DEVELOPMENT DETERMINATION PANEL MEETING

WEDNESDAY 22 APRIL 2020

DA2019/1403 - 75 THE CORSO, MANLY - ALTERATIONS AND ADDITIONS TO THE FIRST FLOOR ACCOMMODATION, NEW DOORS TO NORTH STEYNE, REPLACEMENT AWNING TO THE CORSO, SIGNAGE ZONES, AIR-CONDITIONING TO THE ROOF AND OTHER ANCILLARY WORKS AT HOTEL STEYNE

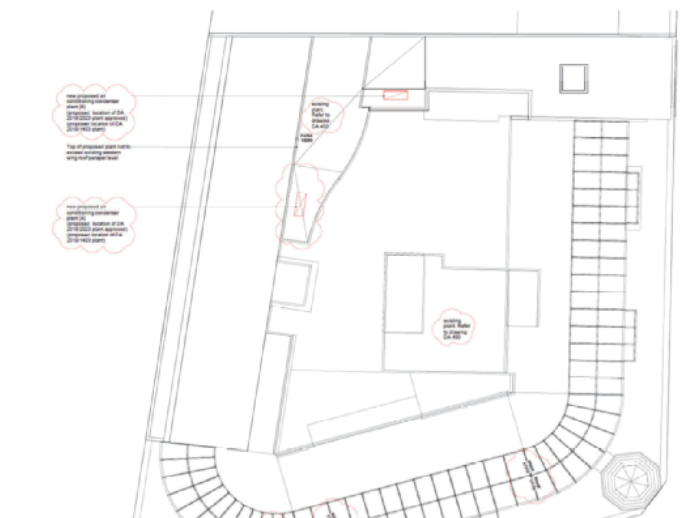
The existing building has a maximum building height of 13.2m. The proposed roof top A/C units are set back from the north and west boundaries and are subject to the 12m height limit. Amended plans have been submitted which depict the height of the existing A/C units located adjacent to the parapet of the western wall. Two A/C units are proposed at the upper roof level. Unit A is in close proximity to the existing A/C units next to the western parapet and unit B is located near the northern boundary wall. The proposed A/C units measure 11.5m in height from ground level and therefore sit below the maximum 12m height limit. The units are set back 11.6m and 14.9m from the western boundary to Henreitta Lane and sit below the 11.76m western parapet height, refer to plan and section below.

Exterior Elevations - External
Awning Improvements and
Signage

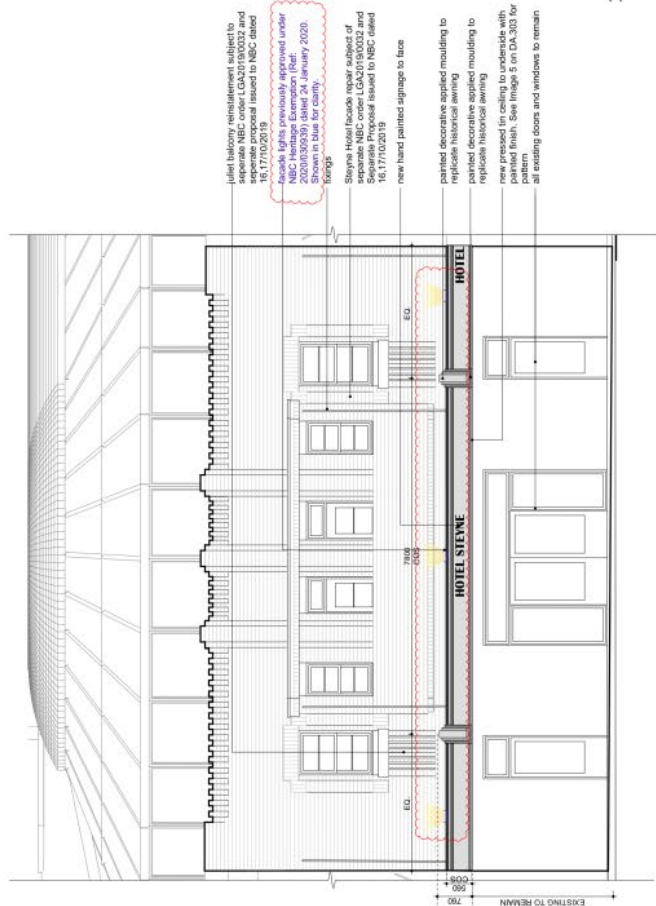
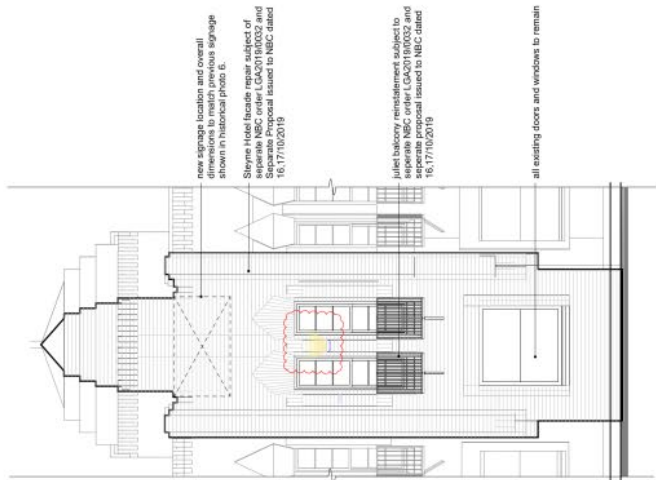
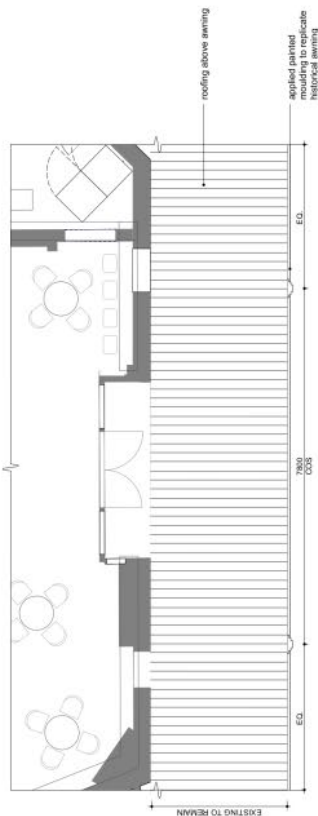
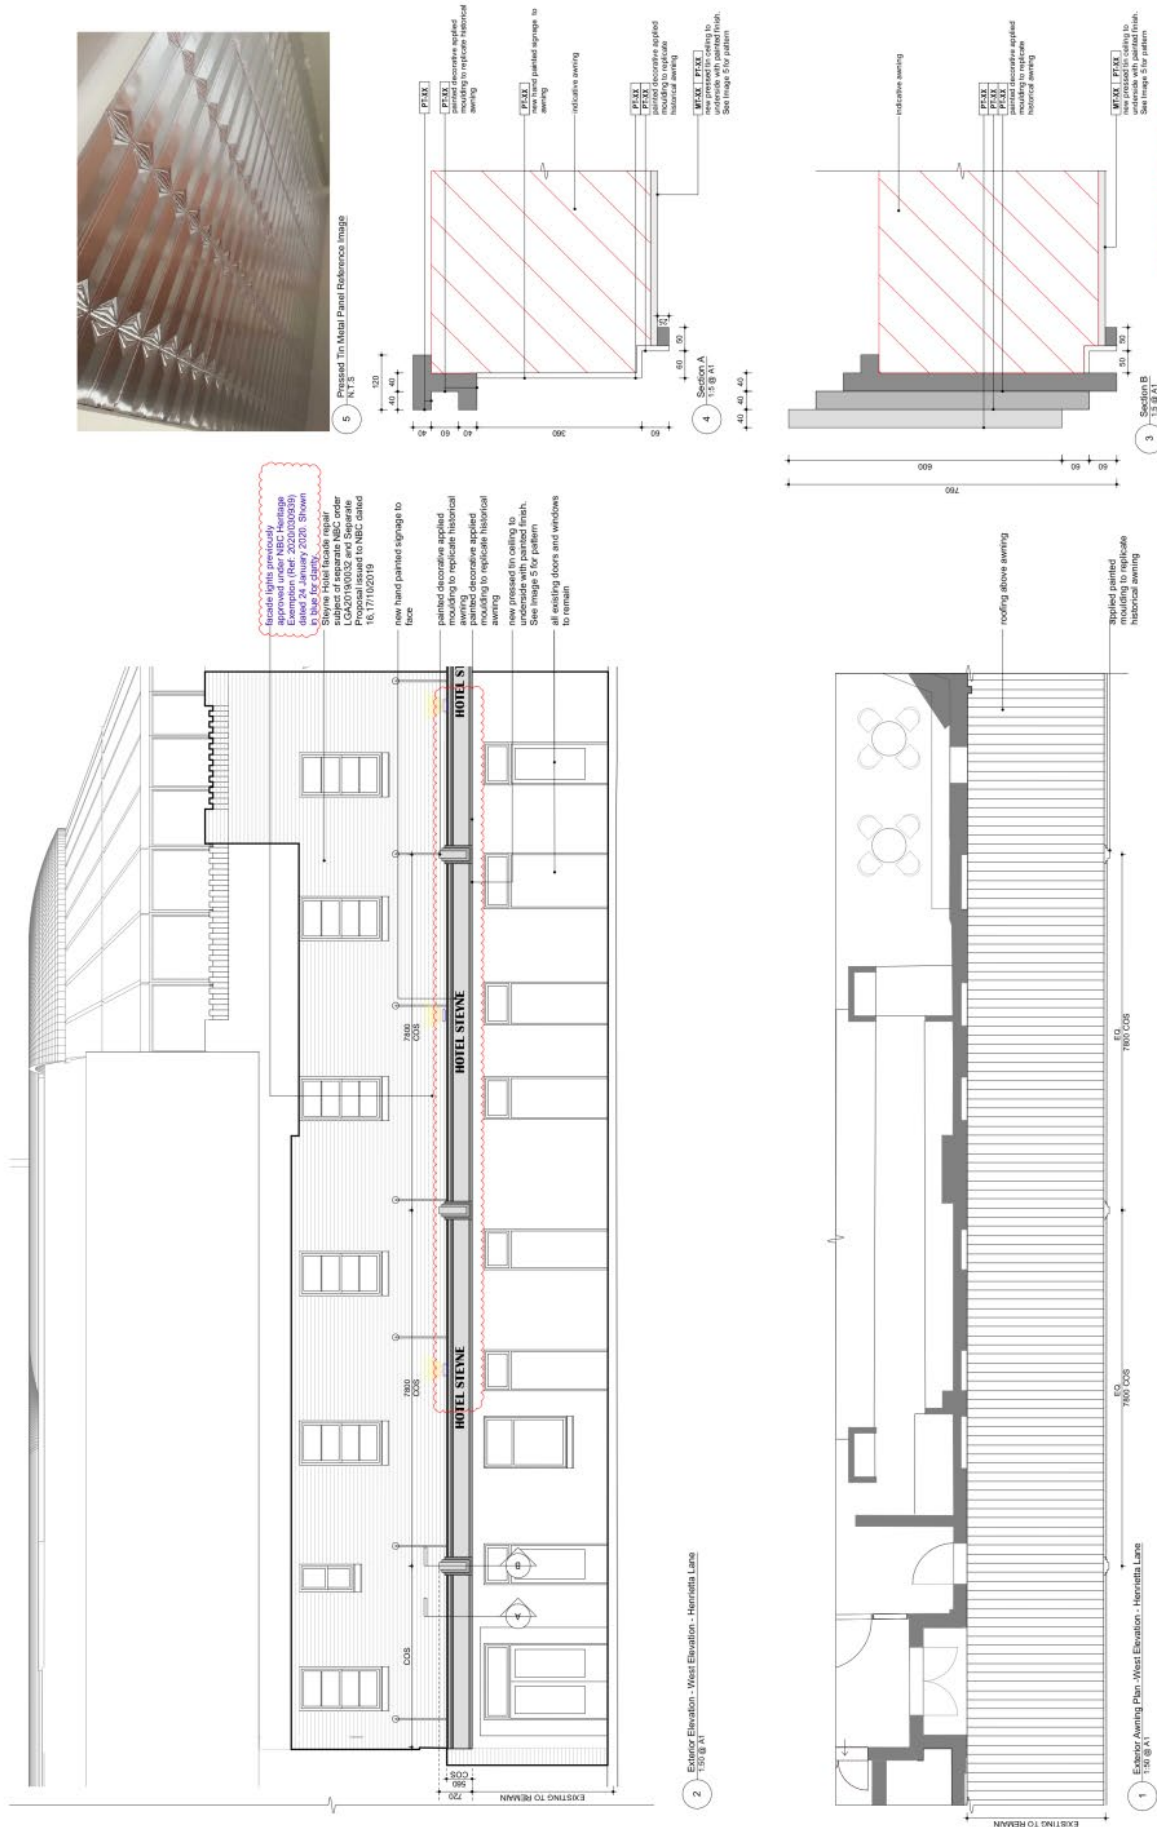
Proposed signage shown on DA.300 and the symmetrical signage shown on DA.301 Revision E, both noted as "new blade signage - Location and overall dimensions to match previous signage shown in historical photo 3", are not acceptable as they are considered not original. A condition requires the submission of a DA for the detail / content of all future signs and reference will be made that the blade signs are not supported.

Section showing the depth of excavation (source Macphail & Sproul architects).

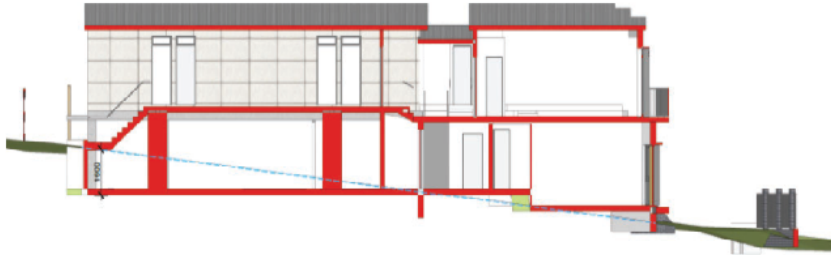
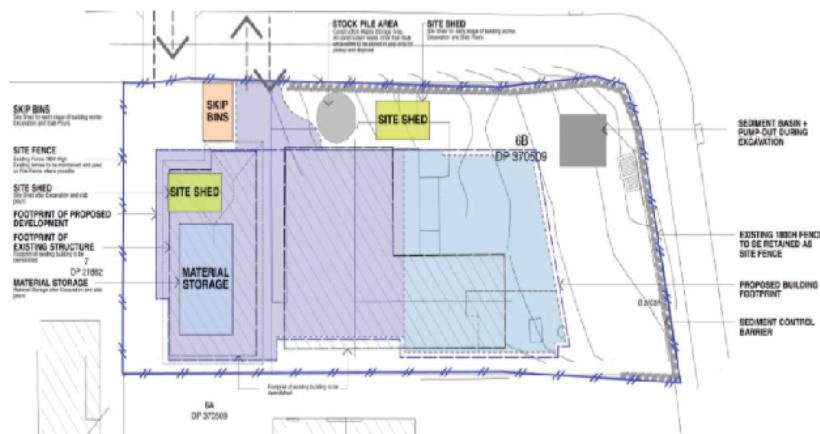
The proposal includes excavation to a maximum depth of 1.6m to create a sub-basement parking area, see section below. The excavation is contained in the southern half of the site, see plan below which shows the excavation area in purple.

Figure 1 - Eastern elevation non-compliance with wall height.

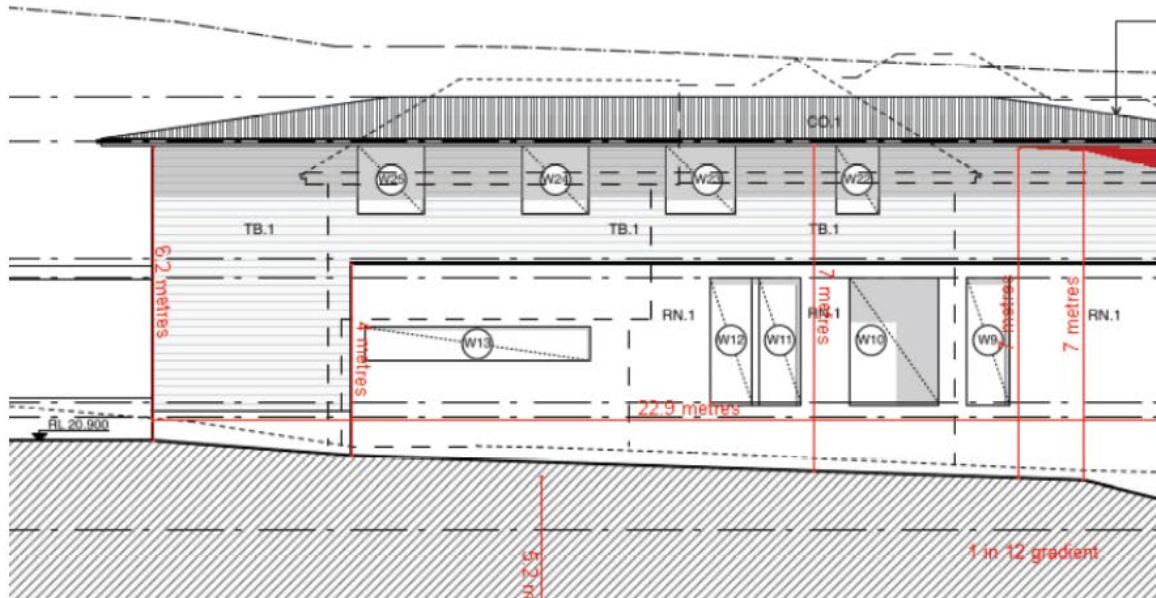
The proposal is non-compliant with clause 4.1.2.1 Wall Height, which requires a maximum wall height of 7m based on the site gradient. A portion of the dwelling is non-compliant with wall height as shown in the below Figure.

Figure 1 - Non-compliant portion of building shown in red.

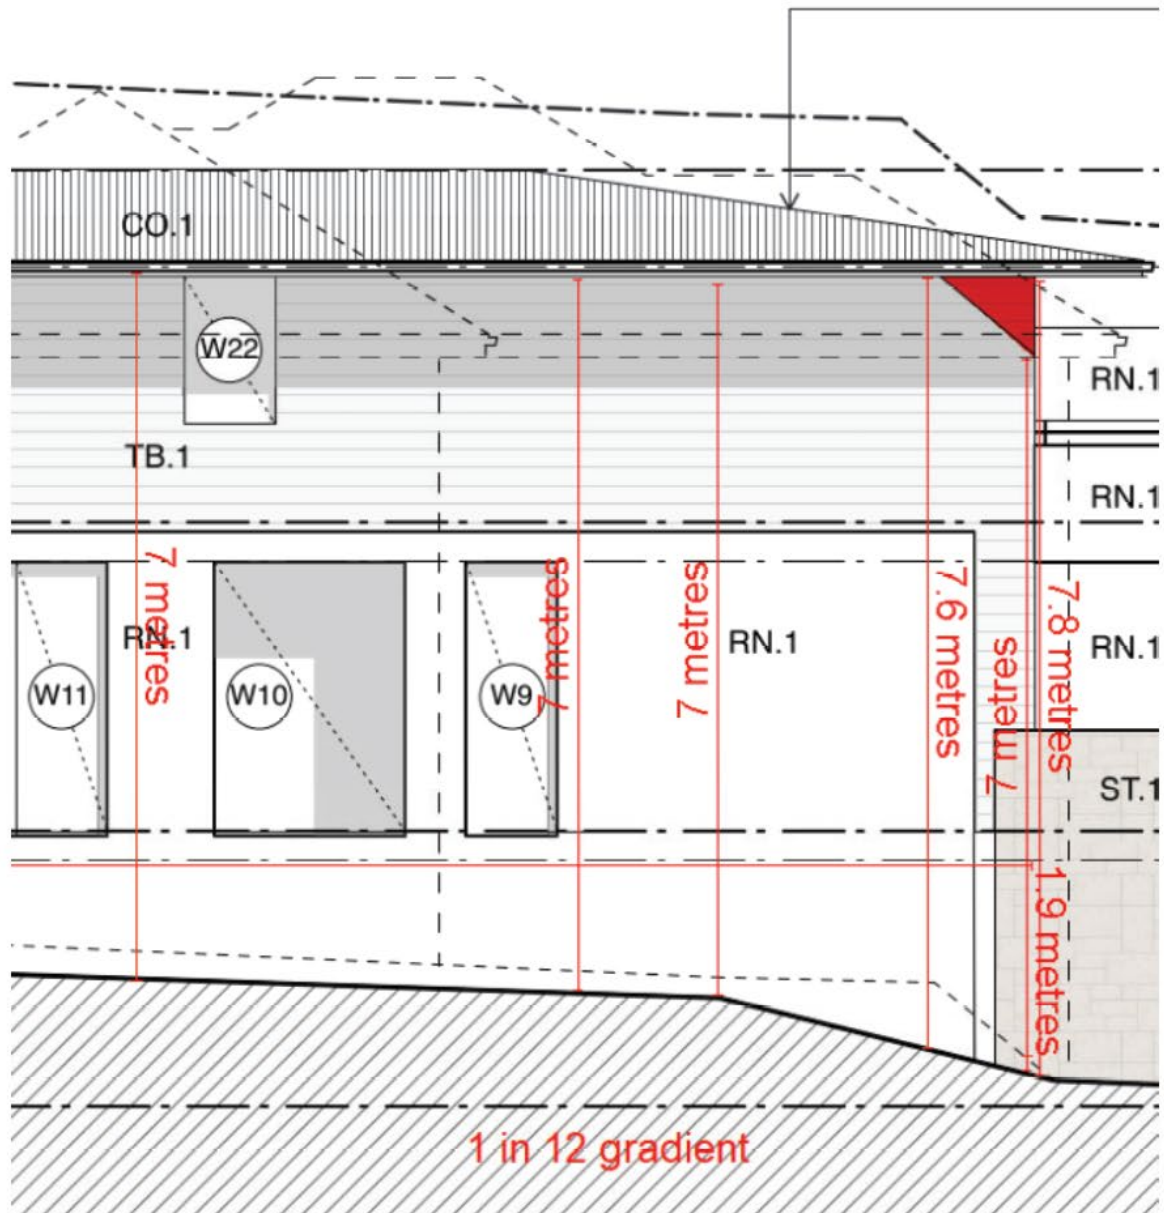
The DCP requires that development is to have a side setback one third of the wall height. The proposal presents a minor non-compliance for the upper floor on the eastern elevation. The first floor is setback 2.5m on the eastern elevation. The non-compliant portion of the building is demonstrated in the below
